Road Safety Audit Response Report

Client	Avant Homes
Project	Thurnscoe Bridge Lane, Thurnscoe
TPS Reference	P2423
Date Prepared	10.07.25
Prepared By	JT
Checked By	JA

Road Safety Audit Stage 1

Thurnscoe Bridge Lane, Thurnscoe, Barnsley – Road Safety Audit Stage 1

Title
Proposed Right Turn
Ghost Island Arrangement

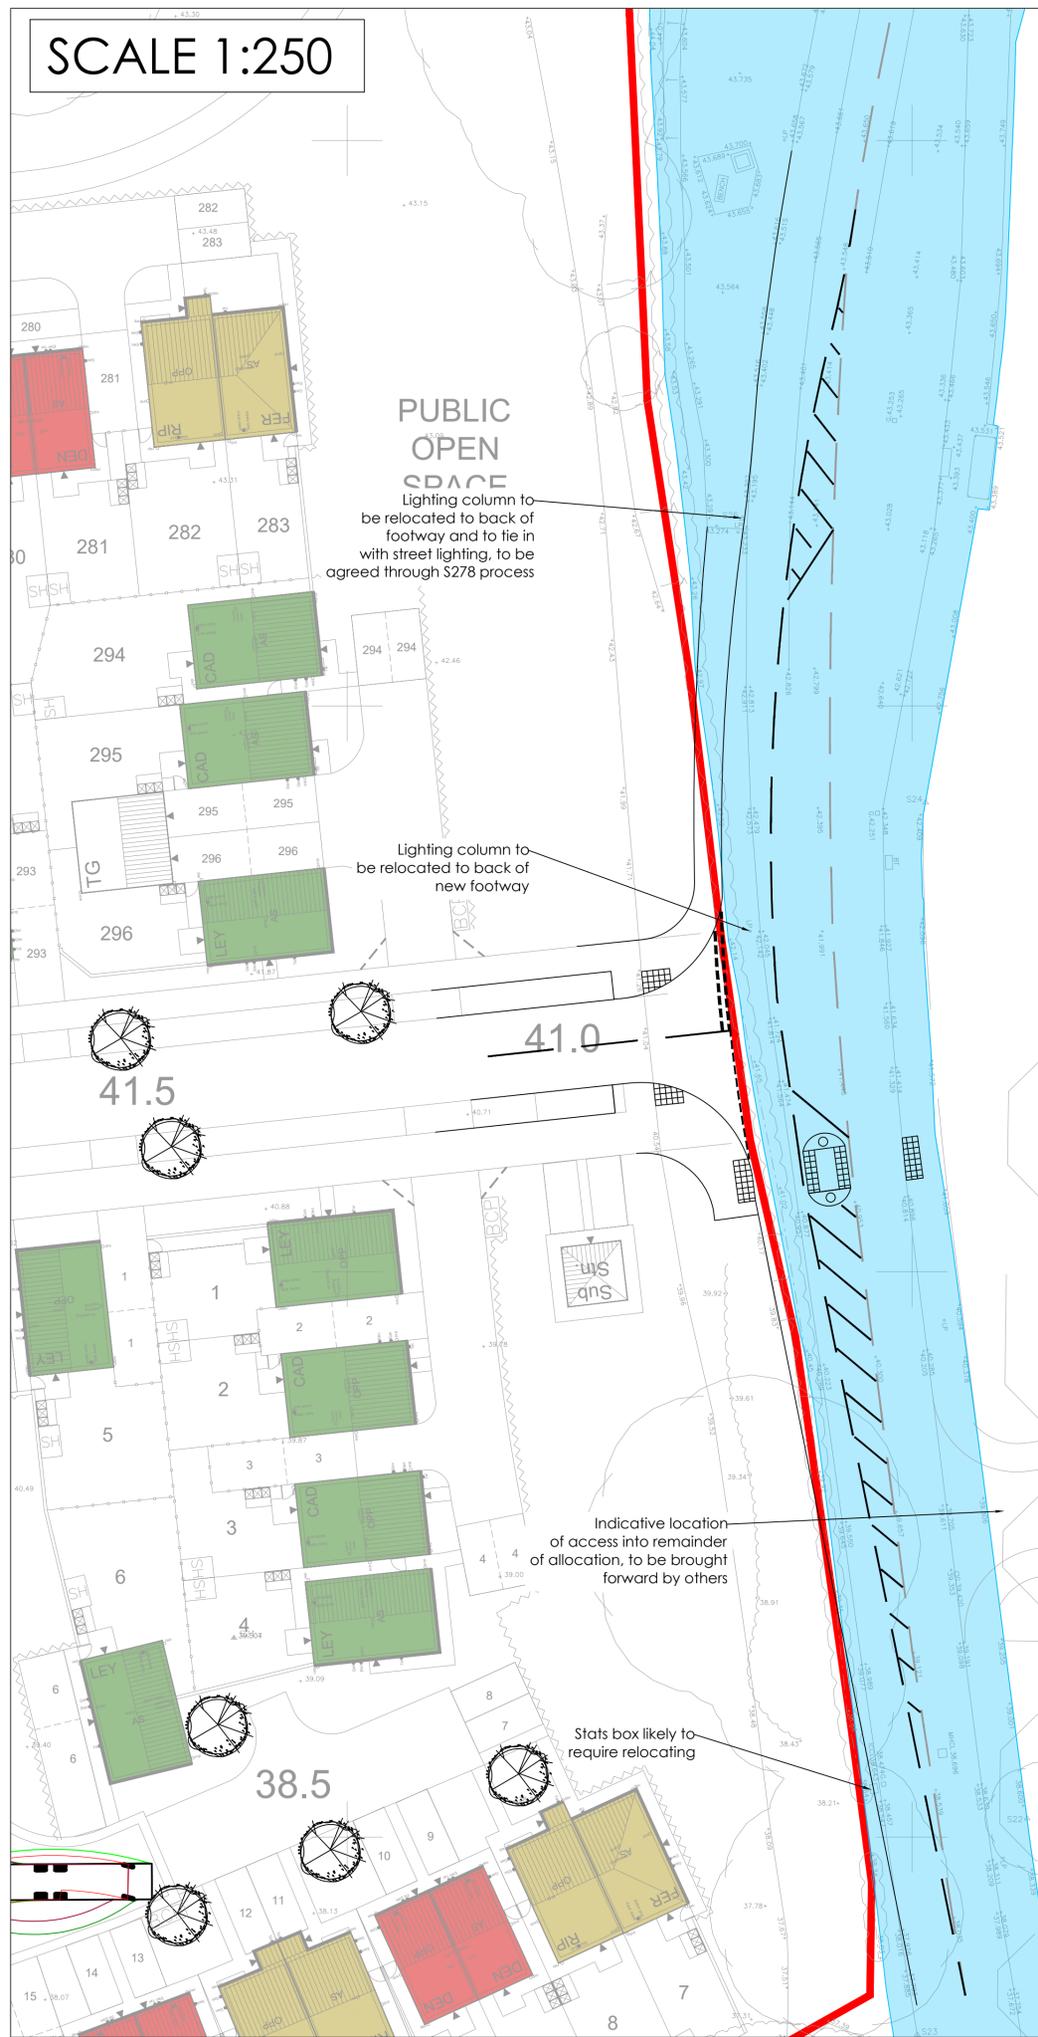
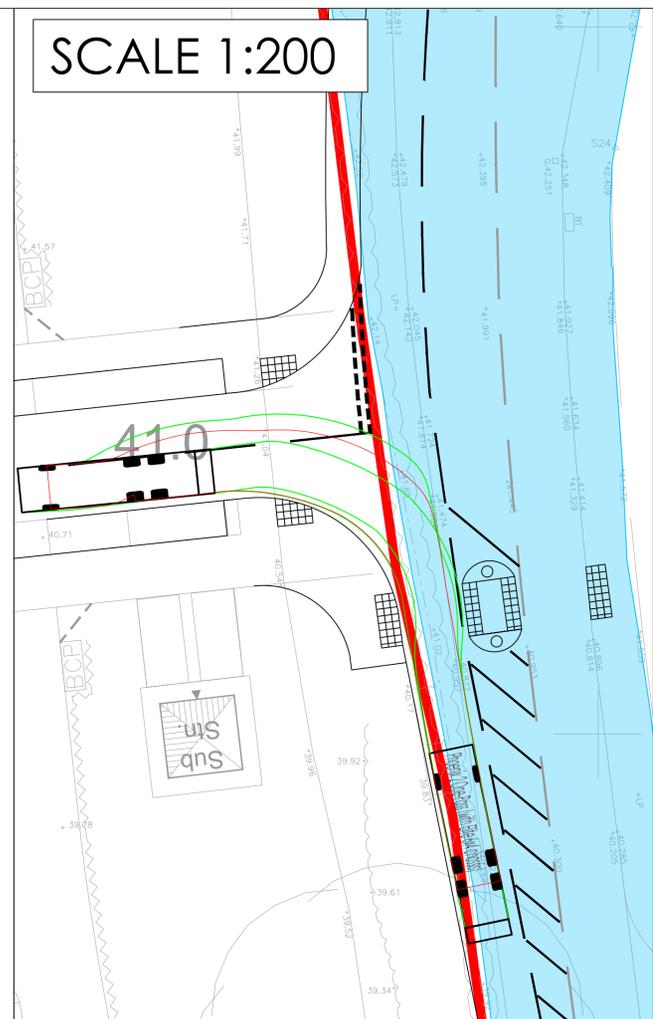
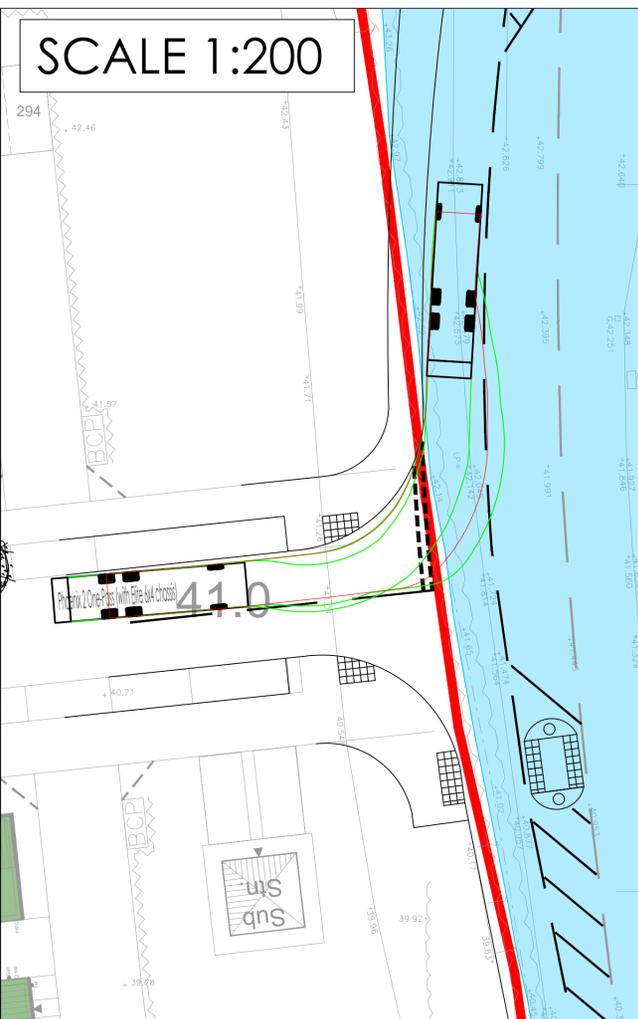
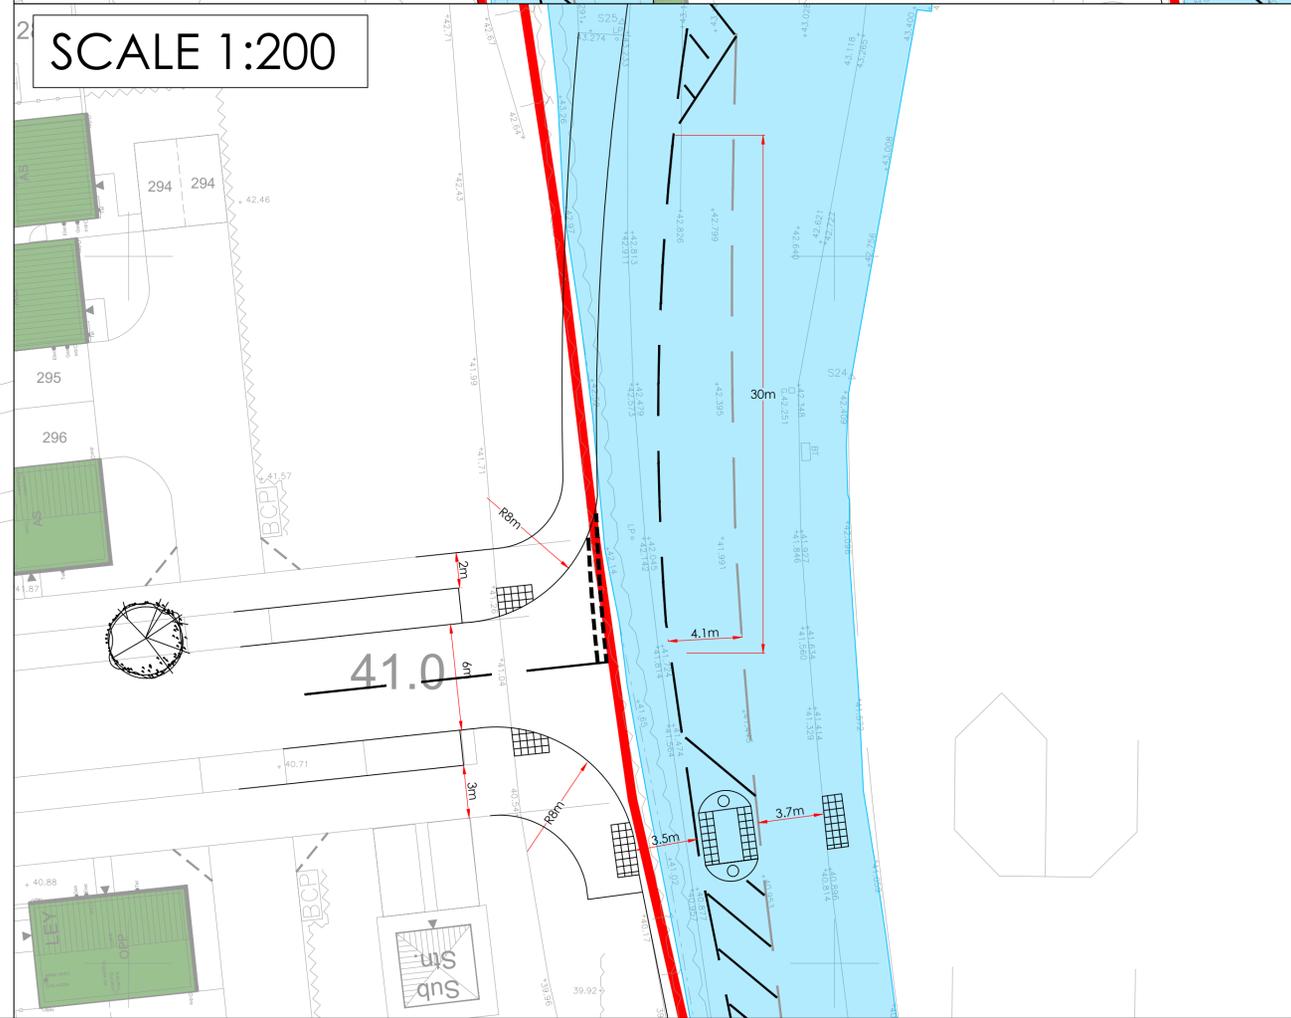
RSA Problem	RSA Recommendation	Design Organisation Response	Overseeing Organisation Response	Agreed RSA Action
<p>A-01 - Thurnscoe Bridge Lane – South of the development access.</p> <p>Landscaping – Future growth from trees and bushes may obstruct visibility consequentially increasing the risk of junction related collisions.</p> <p>No junction visibility has been indicated on the development access. Whilst this will be sufficient to the north, provision to the south when considering the likely speed of vehicles transitioning from the semi-rural section is likely to require some removal of landscaping. The audit team consider that speeds may be greater than a typical 30mph road on this approach. Future growth from remaining trees and bushes to the southern side of the development access may obstruct visibility consequentially increasing the risk of junction related collisions.</p>	<p>It is recommended that the extents of junction visibility at the development access is established and kept clear of any obstruction that may grow or mature in future years and that the extents of the visibility is clearly marked to aid future maintenance.</p>	<p>Agreed.</p> <p>Visibility splays have been added to the proposed access arrangement drawing which demonstrate that 2.4m x 43m visibility splays can be achieved, commensurate with the posted speed limit on Thurnscoe Bridge Lane.</p> <p>This will aid the future management of the vegetation which fronts onto Thurnscoe Bridge Lane, in that it will be ensured that no vegetation over 0.6m in height obstructs the line of the visibility splay.</p>

<p>A – 02 - Thurnscoe Bridge Lane – Development access and main carriageway</p> <p>Drainage – Insufficient surface water drainage may increase the risk of skidding type collisions at the junction as well as slips and falls by pedestrians.</p> <p>At this early stage, no details have been provided on the proposed drainage arrangements. The site appears to raise up to a higher level than the main carriageway. As such, this may require measures to manage surface water around the junction to reduce the risk of surface water from the development entering Thurnscoe Bridge Lane or standing water and detritus in the junction area that may consequently cause skidding type collisions near the junction or slips and falls by pedestrians crossing in this area.</p>	<p>It is recommended that drainage details are provided at the next stage of road safety audit including gully locations, levels and contours.</p>	<p>Agreed.</p> <p>As part of the S278 package of drawings, drainage details will be provided, and this will be covered by the Stage 2 RSA.</p>

<p>A-03 - Thurnscoe Bridge Lane – Main carriageway.</p> <p>Skidding Resistance – Carriageway surfacing across part lane widths may increase the risk of loss of control type collisions.</p> <p>The drawings indicate that carriageway widening is to be provided with no indication of resurfacing of the existing carriageway nor what skidding resistance is to be provided. There is a risk here that, if widening is provided by means of haunching the carriageway width into the verge, a differential skidding resistance is introduced between the new and old carriageway surfacing. This difference in skidding resistance may increase the risk of loss of control type collisions, especially when the carriageway surface is wet.</p>	<p>It is recommended that the widening provided is done so in full lane widths and the revised crown of the road is located such to avoid the application of any adverse camber.</p>	<p>Agreed.</p> <p>As part of the S278 detailed design, it will be specified that resurfacing is done across the full width of the carriageway over the length of the proposed works.</p>

<p>A-04 - Derry Grove – Near junction with Thurnscoe Bridge Lane.</p> <p>Specific Road Users – Lack of crossing facility may increase the risk of collisions involving users who rely on mobility aids.</p> <p>There is a desire line for pedestrians between the development and facilities to the north. However, there is no provision for pedestrians with mobility issues, specifically those users with prams, wheelchairs or mobility scooters. The alternatives for these users may require them to use drop kerbs provided for driveways or to cross at locations where visibility to approaching vehicles may be otherwise compromised. This lack of dropped crossings on desire lines may increase the risk of collisions involving users with mobility issues.</p>	<p>It is recommended that a dropped pedestrian crossing with (ideally) tactile paving is provided across Derry Grove. This is likely to require the dropped vehicle crossing off Derry Grove for the field access to be removed also.</p>	<p>Agreed.</p> <p>A dropped kerb crossing with tactile paving has been added to the proposed site access arrangement drawing and a note has been added with regard to the reinstatement of a full height kerb where the existing field gate access is located.</p>

<p>A-05 - Thurnscoe Bridge Lane – At the pedestrian refuge.</p> <p>Cycles – Width provision for cycles may increase the risk of shunt or side swipe type collisions involving this user group.</p> <p>Details of kerb-to-kerb widths have not been provided at the proposed refuge. At this location, cyclists may be at risk from motor vehicles passing too close due to a potential ambiguity of width as they overtake the slower moving cycle. This would be especially a problem for northbound</p>	<p>It is recommended that, as per advice in LTN 1/20 Chapter 7, that widths between 3.1m and 3.9m may encourage close overtaking by motor vehicles at pinch points and should be avoided. It is also recommended that wider provision is made for the northbound, uphill direction.</p>	<p>Agreed.</p> <p>The proposed design has been amended to ensure that a width of 3.9m has been provided adjacent the proposed crossing location, in order to be outside of the 3.1m-3.9m distance suggested to be avoided in LTN 1/20.</p>

<p>cyclists who are traveling uphill at this point. Incompatible width provision for cycles may increase the risk of shunt or side swipe type collisions involving this user group.</p>				
<p>A-06 - Thurnscoe Bridge Lane – At the pedestrian refuge.</p> <p>Lighting – Insufficient carriageway surface illumination may increase the risk of collisions involving pedestrians during the hours of darkness.</p> <p>There is currently street lighting provision in the vicinity of the proposed pedestrian refuge. This is likely to provide a standard level of carriageway illumination for a semi-rural/residential frontage. The introduction of a refuge will focus pedestrians to cross at this location where pedestrians may not have enough contrast against background light from the adjacent development and vehicle headlights. Insufficient carriageway surface illumination at the crossing point may increase the risk of collisions involving pedestrians during the hours of darkness.</p>	<p>It is recommended that carriageway surface illumination is provided to higher class/level in the vicinity of the proposed crossing point. This may be as simple as increasing the output from the existing LED luminaries.</p>	<p>Agreed.</p> <p>As part of the S278 detailed design of the access street lighting will be considered to ensure that the crossing point and access is sufficiently illuminated.</p>

Problem Location Plan

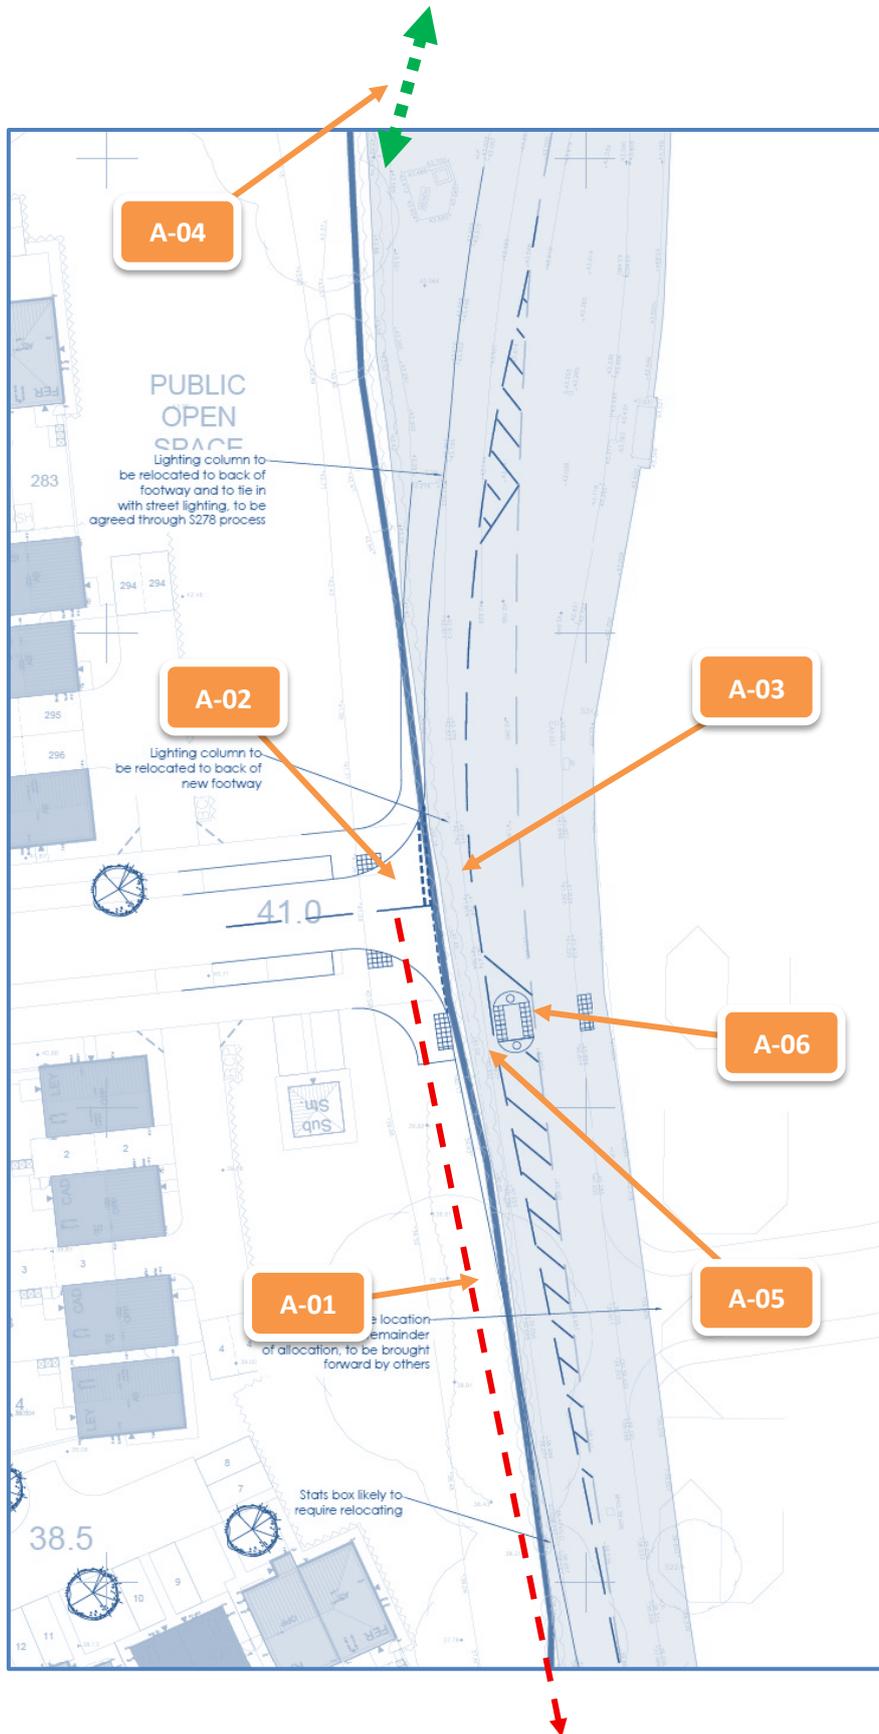
PROBLEM – A-01

Summary: Landscaping – Future growth from trees and bushes may obstruct visibility consequentially increasing the risk of junction related collisions.

PROBLEM – A-02

Summary: Drainage – Insufficient surface water drainage may increase the risk of skidding type collisions at the junction as well as slips and falls by pedestrians.

PROBLEM – A-03

Summary: Skidding Resistance – Carriageway surfacing across part lane widths may increase the risk of loss of control type collisions.

PROBLEM – A-04

Summary: Specific Road Users – Lack of crossing facility may increase the risk of collisions involving users who rely on mobility aids.

PROBLEM – A-05

Summary: Cycles – Width provision for cycles may increase the risk of shunt or side swipe type collisions involving this user group.

PROBLEM – A-06

Summary: Lighting – Insufficient carriageway surface illumination may increase the risk of collisions involving pedestrians during the hours of darkness.

It is recommended that the extents of junction visibility at the development access is established and kept clear of any obstruction that may grow or mature in future years and that the extents of the visibility is clearly marked to aid future maintenance.

It is recommended that drainage details are provided at the next stage of road safety audit including gully locations, levels and contours.

It is recommended that the widening provided is done so in full lane widths and the revised crown of the road is located such to avoid the application of any adverse camber.

It is recommended that a dropped pedestrian crossing with (ideally) tactile paving is provided across Derry Grove. This is likely to require the dropped vehicle crossing off Derry Grove for the field access to be removed also.

It is recommended that, as per advice in LTN 1/20 Chapter 7, that widths between 3.1m and 3.9m may encourage close overtaking by motor vehicles at pinch points and should be avoided. It is also recommended that wider provision is made for the northbound, uphill direction.

It is recommended that carriageway surface illumination is provided to higher class/level in the vicinity of the proposed crossing point. This may be as simple as increasing the output from the existing LED luminaries.
